SERVICE INSTRUCTION**Introduction of a new oil sump assy. for ROTAX® Engine Type 914 (Series)**

ATA System: 78-00-00 Exhaust and Turbocharger

Introduction of a new oil sump assy. for ROTAX® Engine Type 914 (Series).

Fig. 2

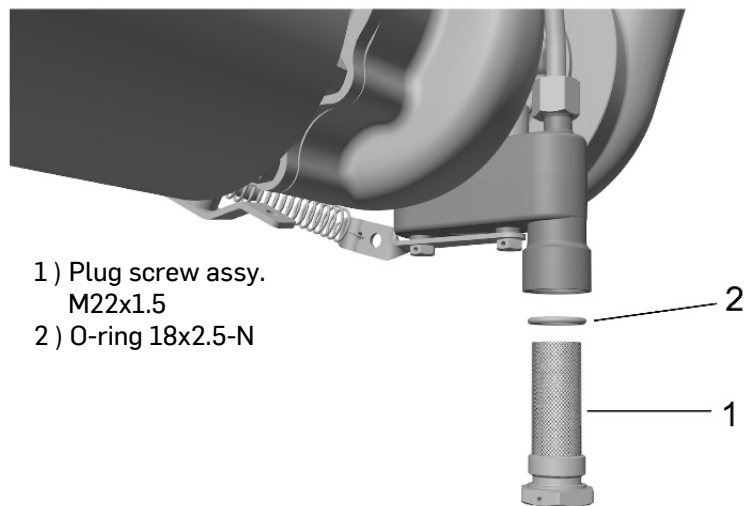
To check and clean the plug screw screen on turbo oil sump assy., the following steps are necessary (see Fig. 2).

Step	Procedure
1	Cut the lock-wire from hex. screws and plug screw.
2	Loosen the plug screw assy. M22x1.5 with the O-ring 18x2.5-N.
3	Drain the residual oil from the oil sump assy.
4	Inspect the plug screw assy. for metal and coked oil particles.
5	Clean the plug screw with suitable cleaning agent.
6	Install plug screw assy. M22x1.5 with O-ring 18x2.5-N into the oil sump assy. Tightening torque 20 Nm (15 ft. lb).
7	Secure the hex. screws and plug screw with lock-wire.

Step	Procedure
4	Install plug screw Assy. M22x1.5 with O-ring 18x2.5-N into the oil sump Assy. Tightening torque 20 Nm (15 ft.lb).
5	Secure the hex. screws and plug screw with lock-wire.

Fig. 3

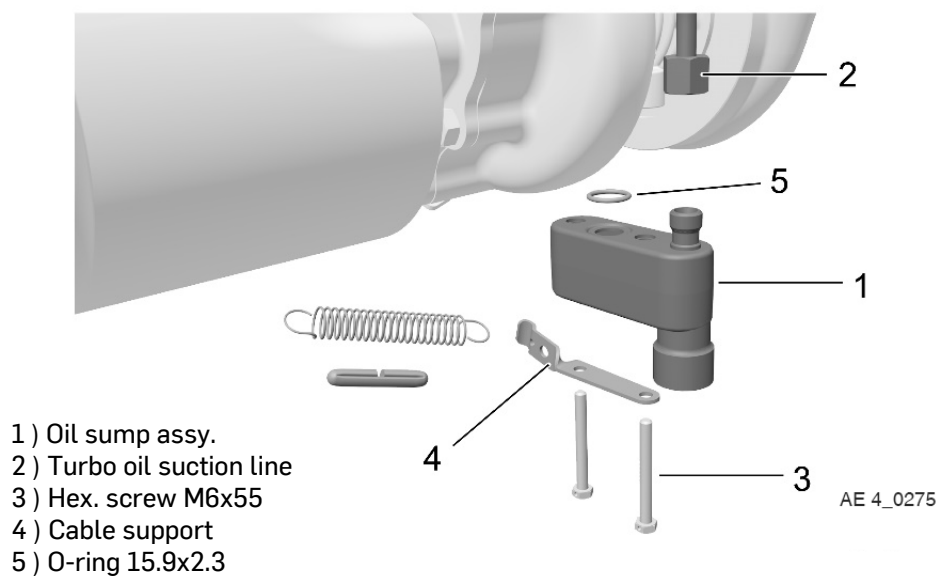
See Fig. 3

Step	Procedure
1	Cut the lock-wire on the plug screw head.
2	Loosen the plug screw assy. M22x1.5 with the O-ring 18x2.5-N.
3	Drain the residual oil from the oil sump assy.
4	Remove tension spring from wastegate flap with a suitable tool.
5	Release collar nut of the turbo oil suction line
6	Loosen the 2 hex. screws M6x55 and remove the cable support, oil sump assy. and O-ring 15.9 x 2.3.

Step	Procedure
1	Place O-ring 15.9x2.3 into the oil sump Assy.
2	Install the oil sump Assy. on turbocharger with support bracket and 2 hex. screws M6x55. Tightening torque 10 Nm (89 in. lb)
3	Tighten collar nut of the turbo suction oil line to 20 Nm (15 ft. lb).

Fig. 7
Oil sump assy. - overview

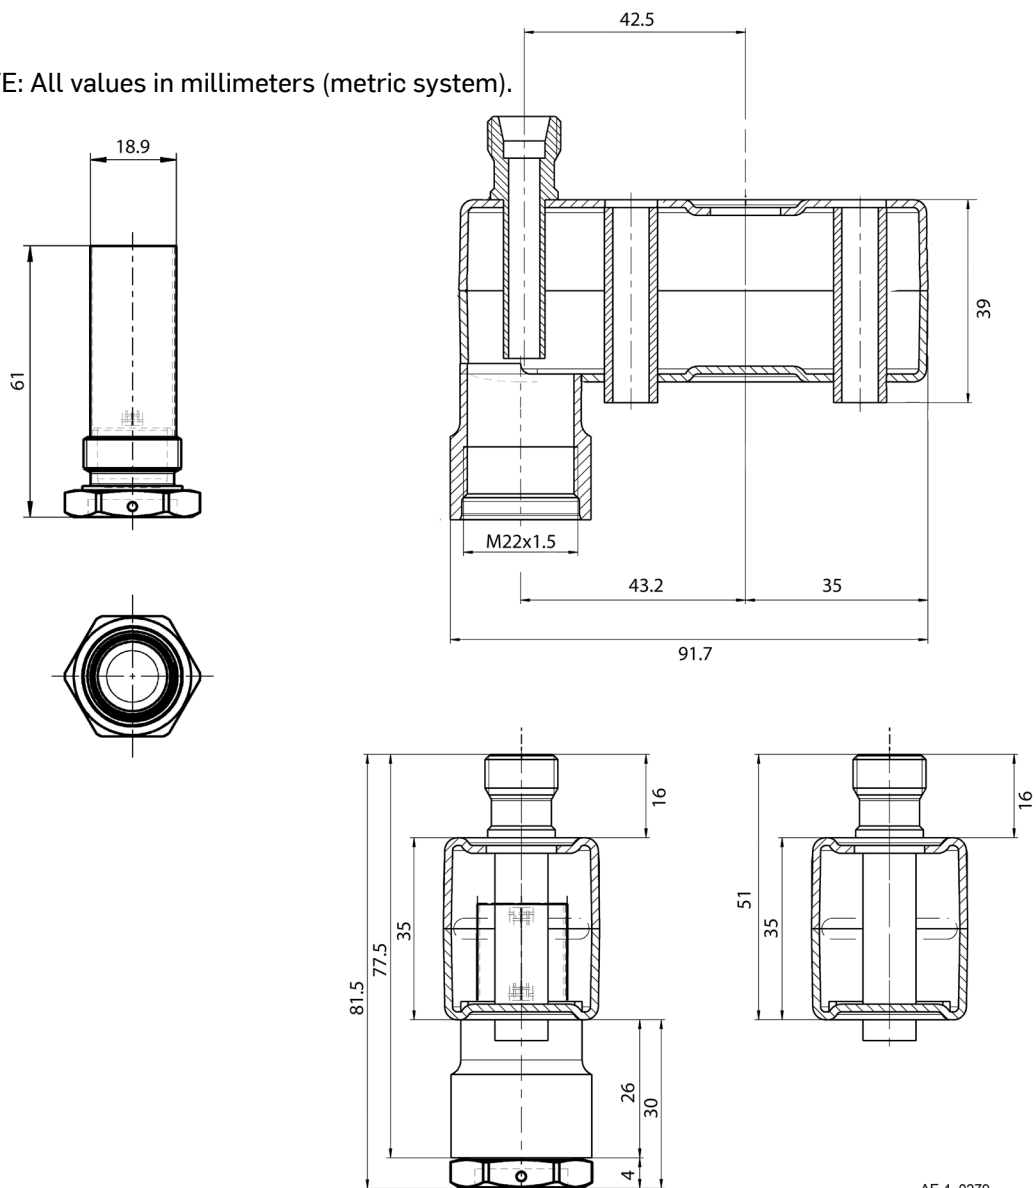
In the course of further development and standardization, the 914 turbocharger oil sump assy. has been standardized to include a plug screw assy. (including screen) to allow inspection and cleaning.
